OAHU DISTRICT BASEYARD MAINTENANCE BLDG.
SHARPER FLATS INDUSTRIAL DEVELOPMENT AT
MOANALUA, HONOLULU, OAHU, HAWAII

AIR CONDITION PLAN-DIAGRAMS
MISCELLANEOUS DETAILS

ADDENDUM #2 DATE: FEB. 1972

STATE OF HAWAII
DEPARTMENT OF TRANSPORTATION
HIGHWAYS DIVISION
OAHU DISTRICT BASEYARD MAINTENANCE BUILDING
SHAFTER PLATS INDUSTRIAL DEVELOPMENT
AT MOANALUA, HONOLULU, OAHU, HAWAII
REVISED PARAPET WALL @ EWA ELEV.
REVISED RAILING @ STAIR #1
REVISED STAIR #2 & RAILING
HERBERT Y. MATSUMURA & ASSOCIATES, INC.
371 KAPIOLANI BLVD. HONOLULU, HAWAII

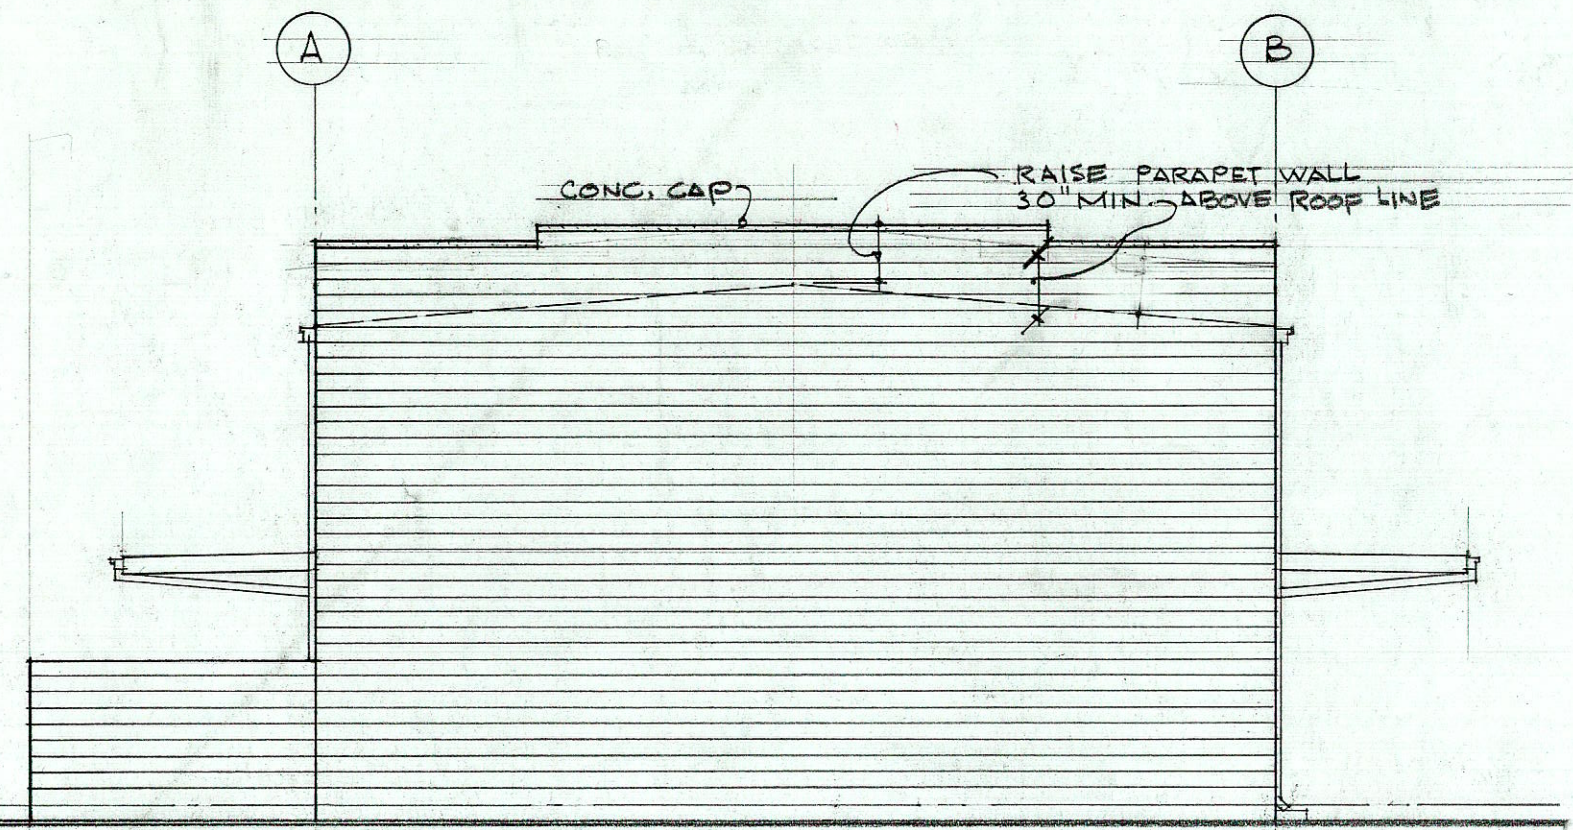
NOTE: THIS GUARDRAIL SECTION SHALL BE PERMANENTLY INSTALLED TO CONC. SLABS W/ PIPE SLEEVE AND GROUT.

SECTION "B"

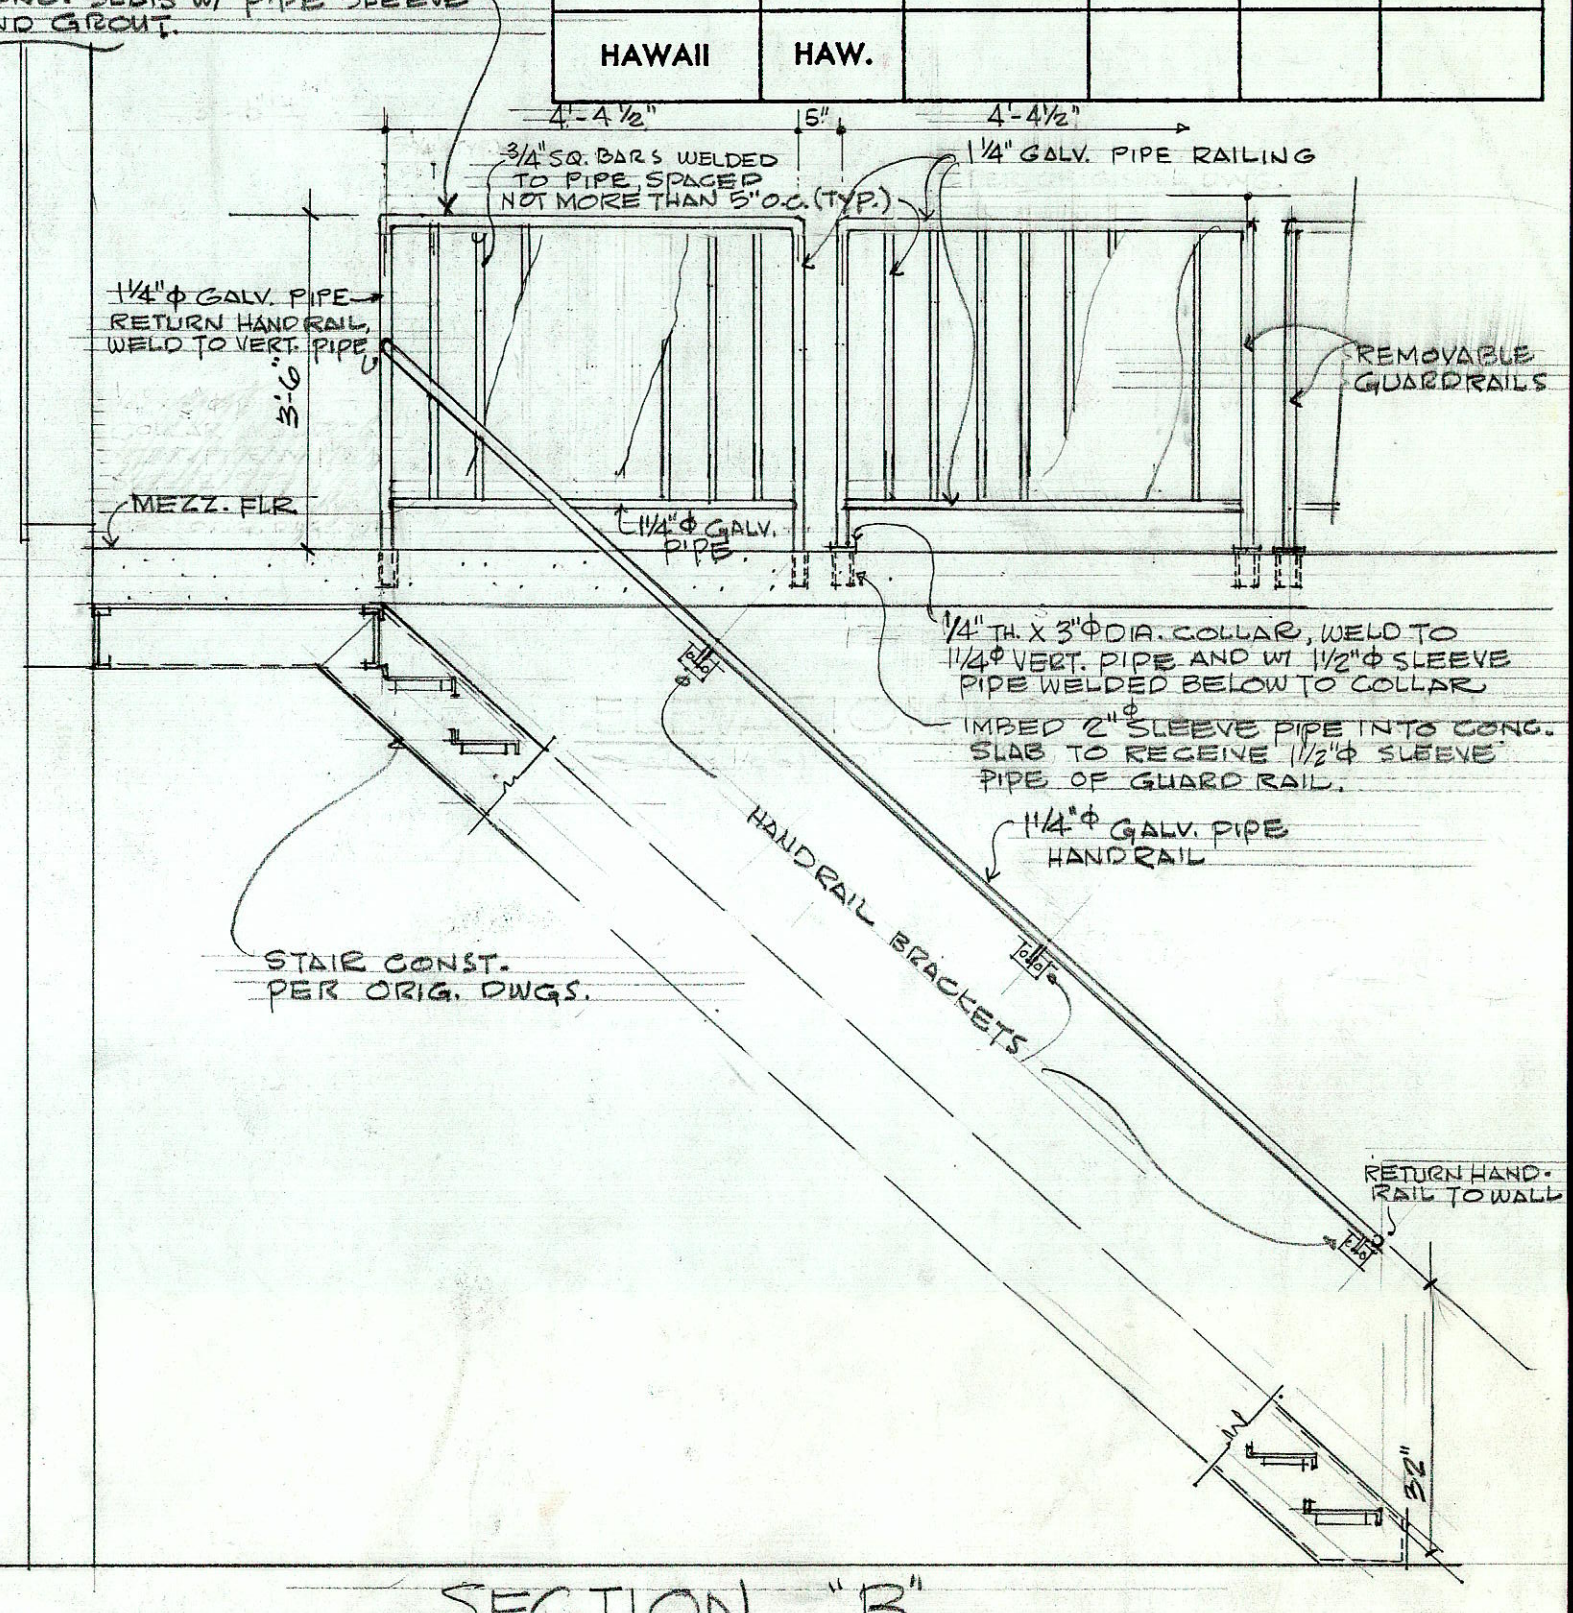
**STAIR #1 - REVISE STAIR RAIL & GUARD RAIL
ADD HANDRAILS**
